Access Compliance Report

Public Rights-of-Way

Intersection ID: 54365	Main Street: COLLINS_FORD_RD	Cross Street: GANNON_DR	Location:	N
ADA ID: C582B26866CF	Ramp Type: Perp	Initial Pass/Fail: Fail	Overall Compliance: No	Severity Score: 12.5
Codes/Mitigation Info/Possible Solution		Field Measurements/Component Compliance

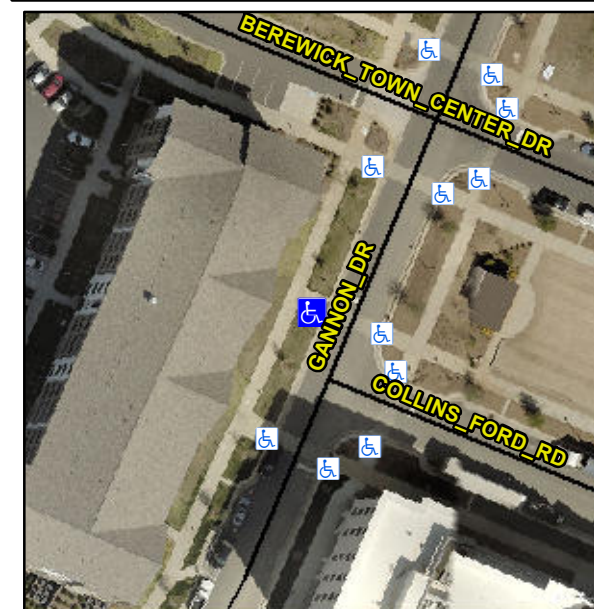
R304.2.2

Compliance	Description	Data	Compliance	Description	Data
N/A	Ramp Length (in)	72.0	No	Ramp Slope (%)	9.3
Yes	Ramp Width (in)	94.5	Yes	Ramp XSlope (%)	0.1
N/A	Flare Type LT	N/A	N/A	Flare Type RT	N/A
N/A	Flare Slope LT (%)	N/A	N/A	Flare Slope RT (%)	N/A
N/A	Flare Traversable LT?	N/A	N/A	Flare Traversable RT?	N/A
N/A	Landing Length (in)	N/A	N/A	DWS Provided?	N/A
N/A	Landing Width (in)	N/A	N/A	DWS Contrast?	N/A
N/A	Landing Slope (%)	N/A	N/A	DWS Length (in)	N/A
N/A	Landing X Slope (%)	N/A	N/A	DWS Full Width?	N/A
N/A	Landing Curb? (Y/N)	N/A	N/A	DWS Offset (in)	N/A
N/A	Shared Landing?	N/A			
N/A	Gutter Ponding?	N/A	N/A	Gutter Slope (%)	N/A
N/A	Gutter Lip Ht (in)	N/A	N/A	Gutter X Slope (%)	N/A
N/A	Painted X Walk1?	Yes	N/A	Painted X Walk2?	N/A
	X Walk 1 Direction	To SE		X Walk 2 Direction	N/A
N/A	X Walk 1 Width (in)	97.5	N/A	X Walk 2 Width (in)	N/A
	X Walk 1 Slope (%)	2.8		X Walk 2 Slope (%)	N/A
	X Walk 1 X Slope (%)	1.6		X Walk 2 X Slope (%)	N/A

Remove & Replace Entire Ramp.
